Updated version of details on objection to M2017-049

Details related to Objections to the Hitch Rack Ranch Quarry Permit Application (M2017-049)

The figure on the next page is an extract from Figure C-2, as amended in the 30 October submission. It depicts the portion of the map that includes Section 16, where the majority of the mining activity will be occurring.

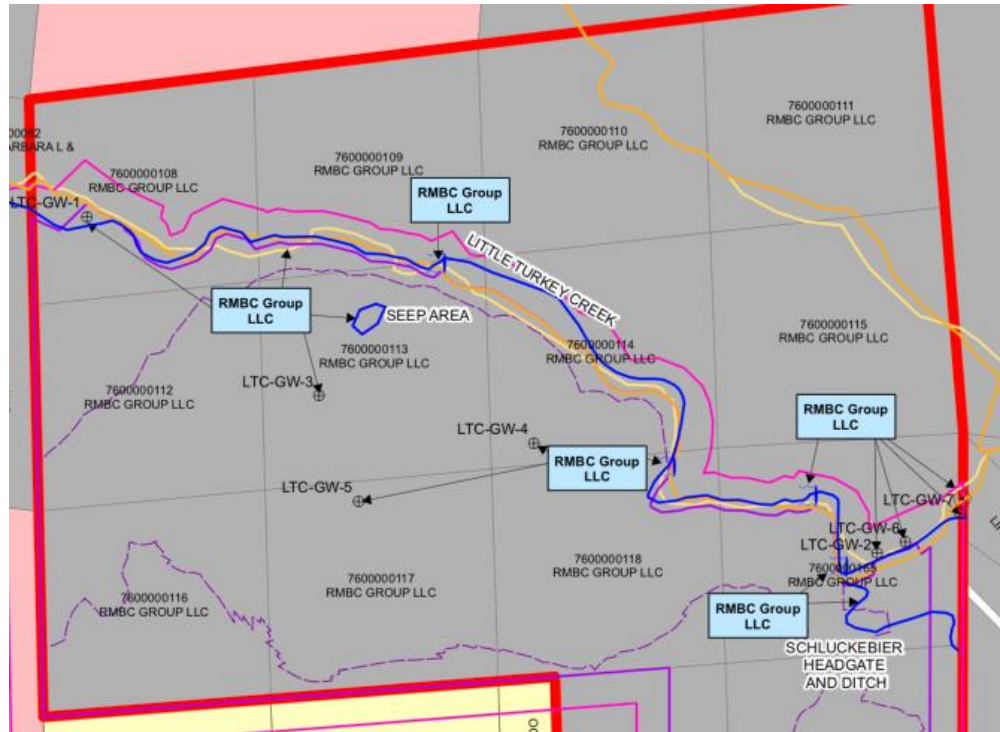
There are numerous omissions and inaccuracies in this map:

- 1) The map includes two different colors for roads within Section 16 (orange and yellow). There are NOT two roads.
- 2) Several segments of the line depicting the northern boundary of the permit area within Section 16 are missing. Knowing the EXACT location of the permit boundary with respect to Little Turkey Creek Road is critical to owners of the road easement.
- 3) A segment of the line depicting the northern boundary of the affected land area within Section 16 is missing. Knowing the EXACT location of the boundary of the affected lands with respect to Little Turkey Creek Road is critical to owners of the road easement.

- 4) There are numerous errors in the depiction of the locations where the road crosses the creek.
- 5) The four culverts marked as owned by RMBC Group are located within the road easement and were installed in 2013 by the Eagles Nest Association.

- 6) The location and the ownership of the gate depicted on the eastern edge of Section 16 are both incorrect.
- 7) Two other existing gates are NOT included in the figure.

- 8) The location and ownership of fences are not included in the figure, although an icon for fences is shown in the legend.
- 9) There is an inconsistency in the location of the monitoring wells between Figure C-2 and Figure 1-1 of NORWEST's "Transit Mix Concrete Co. Hitch Rack Ranch Quarry Surface Water and Groundwater Monitoring Program".

- 10) The depiction of the Schluckebier Headgate and Ditch is totally inaccurate.
- 11) Other water retention and diversion structures within Section 16 are omitted from the figure (e.g., dams, pipelines and ditches).

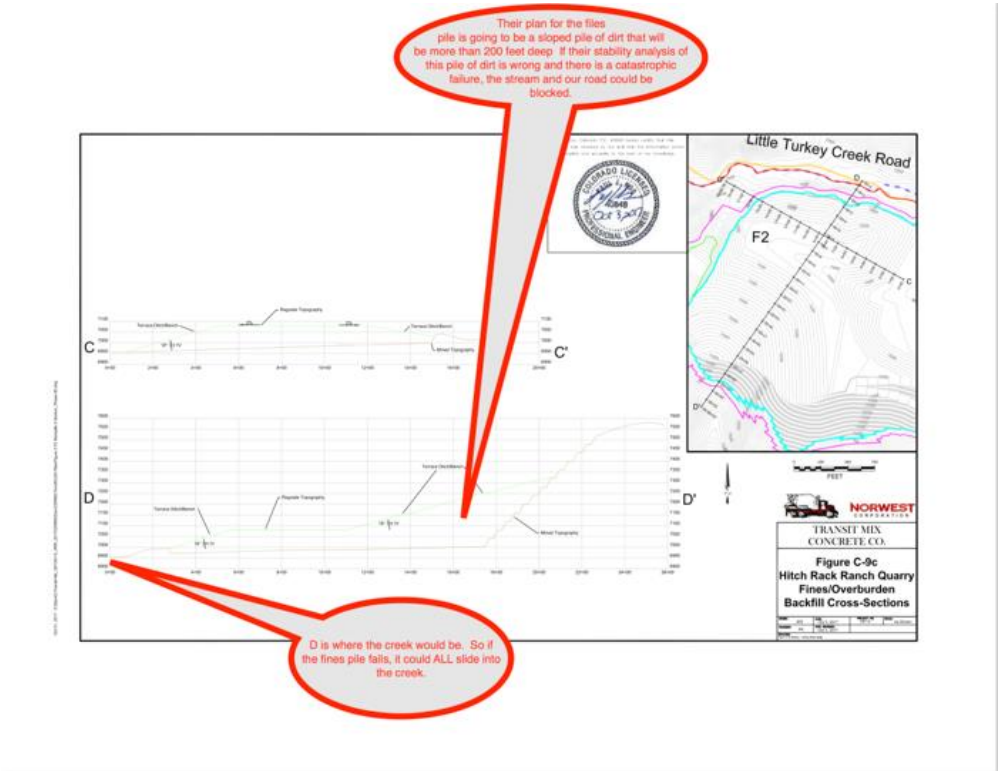
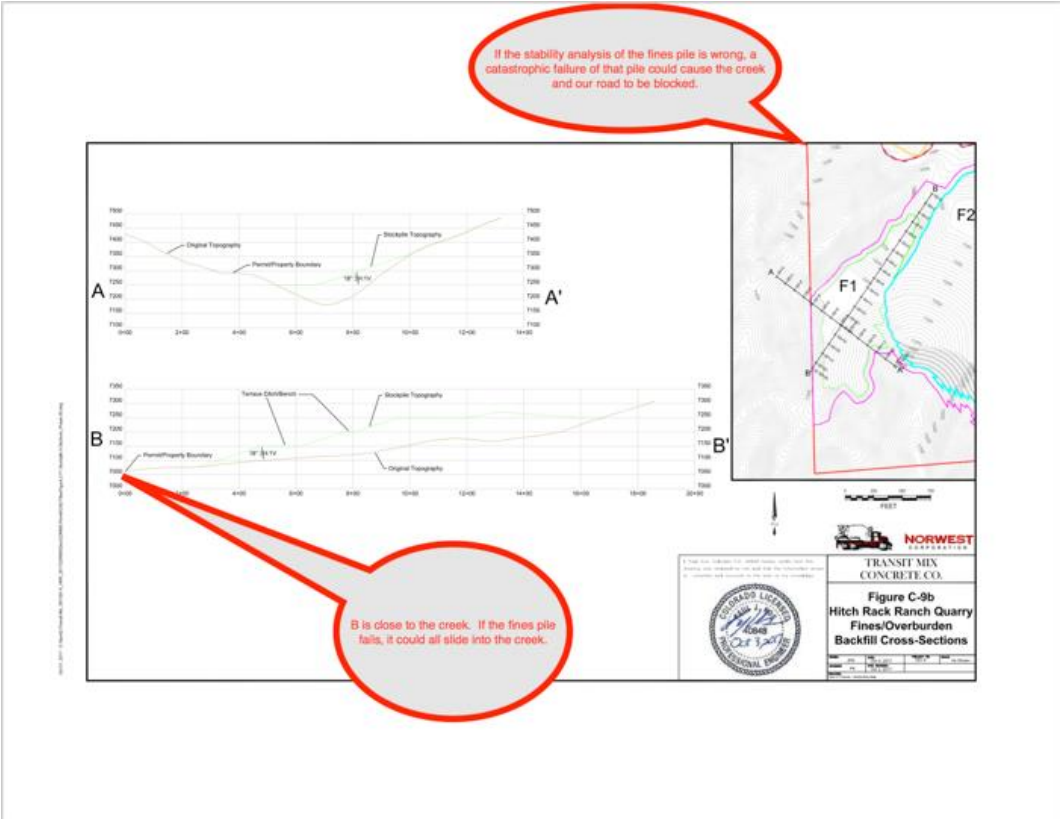
Figures C-9b and C-9C (shown on the next page) depict the proposed fines piles. Point B in Figure C-9b is at the lower end of the F1 fines pile. That pile of material will be over 100 feet deep and the lower end of it is quite close to Little Turkey Creek. Point D in Figure C-9C is at the lower end of the F2 fines pile. That pile of material will be over 200 feet deep and the lower end of it is also quite close to Little Turkey Creek.

Given the proximity to the creek and the planned depth of the fines piles, the stability of those piles will be critical to preventing landslides of material into the creek. The application includes a Stability Analysis for the Fines Pile (NORWEST, Hitch Rack Ranch Quarry Waste Stockpile Stability Analyses, dated 29 August 2017). However, we know from the historical record at Pike View Quarry that stability analyses performed by the applicant's engineers can be WRONG. If any of the stability analyses for this permit are incorrect and there is a catastrophic failure of these fines piles, there could be a landslide which could block Little Turkey Creek, which could damage the creek and Little Turkey Creek Road.

Figure C-3 (shown below) shows the locations of the test bores drilled in 2014 and 2015.

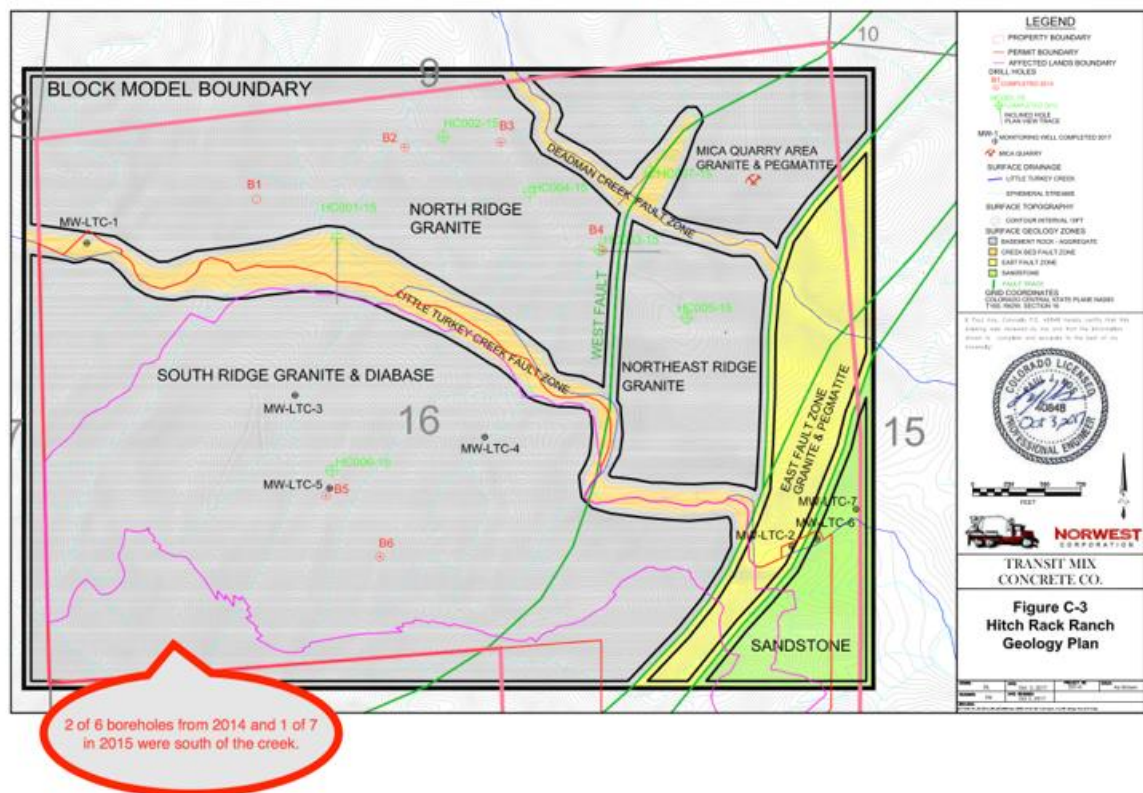
In their stability analysis for the pit walls, (NORWEST Geotechnical Pit Wall Geotechnical Assessment – Rev 0, dated Sept 11, 2017), NORWEST admits that the data collection from the 2014 drilling contained only limited geotechnical information and they therefore did not include data from those holes in their subsequent analysis. They also indicate that only 1 of 7 test bore holes completed in 2015 were drilled south of the creek. On pages 8 and 9 of their report they admit that “limited data is available for the proposed pit area but some aspects of the structural conditions are expected to be similar given the similar rock mass conditions, however additional drilling will be required to characterize the structure of the ultimate quarry pit footprint.”

In NORWEST’s analysis for the 2016 permit (M-2016-010) “Hitch Rack Ranch Pit Wall Geotechnical Assessment – Rev. B”, dated January 26, 2015 the engineer recommended: “Additional geotechnical drilling and analyses are required to confirm conditions prior to mining the area south of Little Turkey Creek.” In the transcript from the October 2016 Board Hearing, the CDRMS staff indicated “we have a commitment in the application that before they open that south pit, there’s going to be a lot more research done” (Page 8974 of the Administrative Record).

Transit Mix did not follow the 2016 recommendation of their engineers and has failed to meet the commitment made in the 2016 application to perform more analysis before the south pit is opened for mining. Analysis and conclusions of stability analysis for this permit are therefore primarily based on data taken from bore holes that aren’t even located within the area to be mined and yet the engineering analysis proceeded as though the data being used was a sufficient sample on which to draw their conclusions. If the pit wall stability analysis done by Transit Mix’s engineers for this quarry is based on inadequate data and ends up being *wrong*, there could be a catastrophic failure of the pit walls.
